DEPARTMENT OF THE ARMY
SAVANNAH DISTRICT, CORPS OF ENGINEERS

SUSTAINABLE DESIGN STUDY FOR COMBAT AVIATION BRIGADE SEPARATE BATTALIONS COMPLEXES

Final Submittal-March 30, 2000

**REDESIGNED SITE PLAN
C.A.B. AND SEPARATE BATTALIONS COMPLEXES**

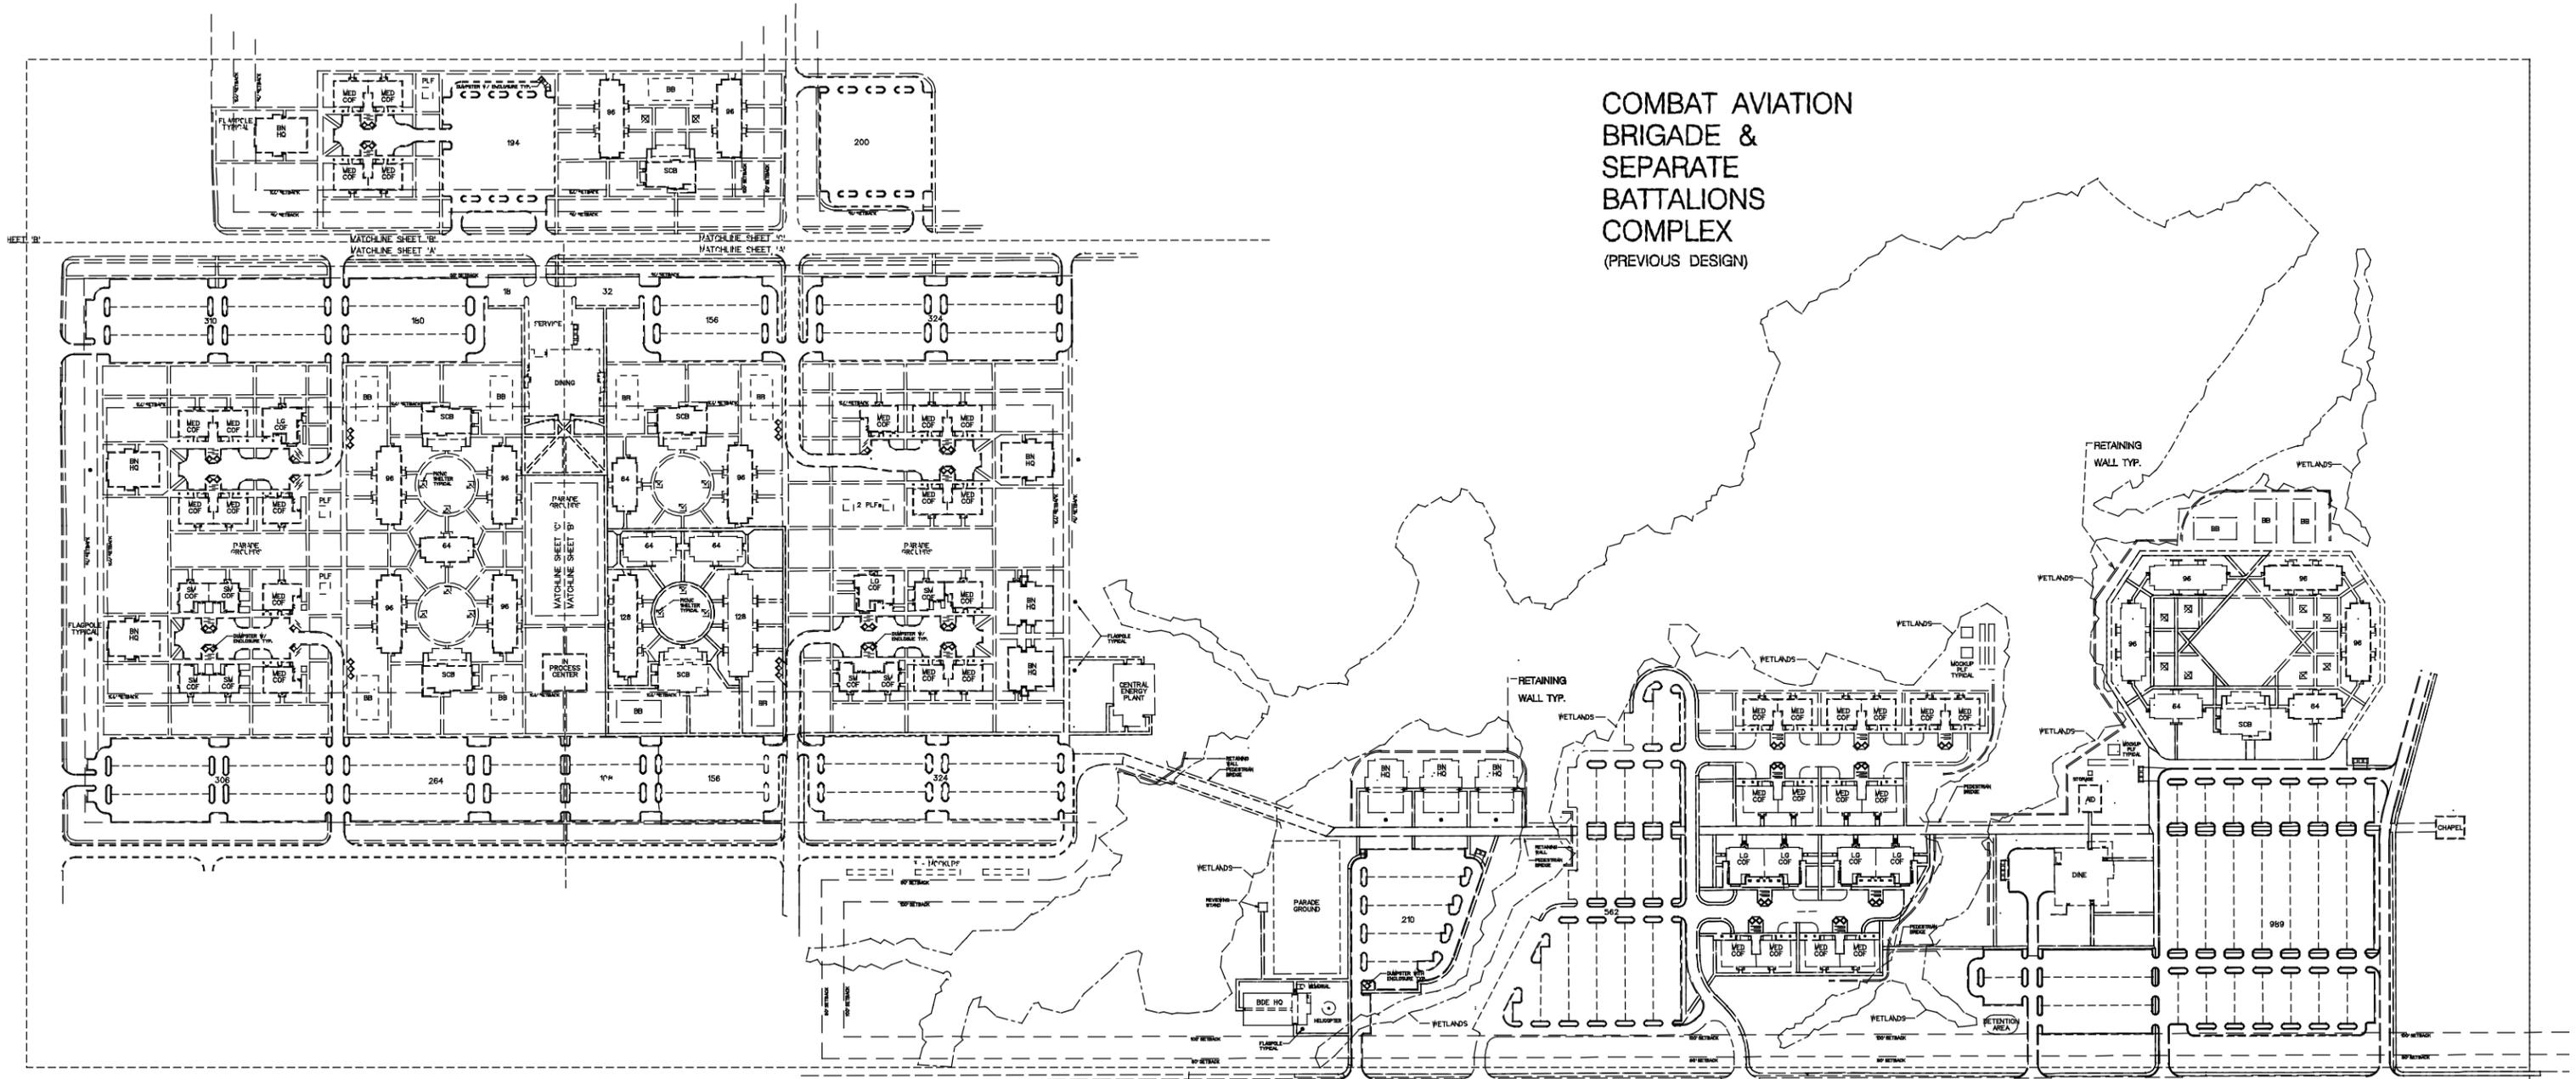
Asked how they would compare the current design's relative impact on the wetlands area to that of the site plan proposed in the Sustainable Design Study, members referred to the fold-out drawing that shows the proposed site plan redesign (see Section II, Site Analysis, p. 7 and 8). The dashed lines indicate building locations in the original design. Even a cursory glance reveals that the redesign has pulled buildings in from the edge of the wetlands. Thus construction will take place at a substantial remove from the wetlands

Site cost could be more, not less, by revising the site layout of the CAB. Less land will be disturbed, but the site will require extensive retaining walls with railing to prevent the site from impacting the wetlands. If site were spread out more, the need for retaining walls could be removed. The additional area could be replanted, and would still remain a green area.

CAB COF access drives must be revised to tie into Longstreet opposite from Honeycutt Road. A traffic light is programmed to be installed at this location.

Response: *We don't really understand this comment inasmuch as by pulling the buildings further away from the wetlands we are left with more room to grade thereby lessening the need for retaining walls.*

Response: *We agree that the CAB COF access drives should be relocated to align with Honeycutt.*
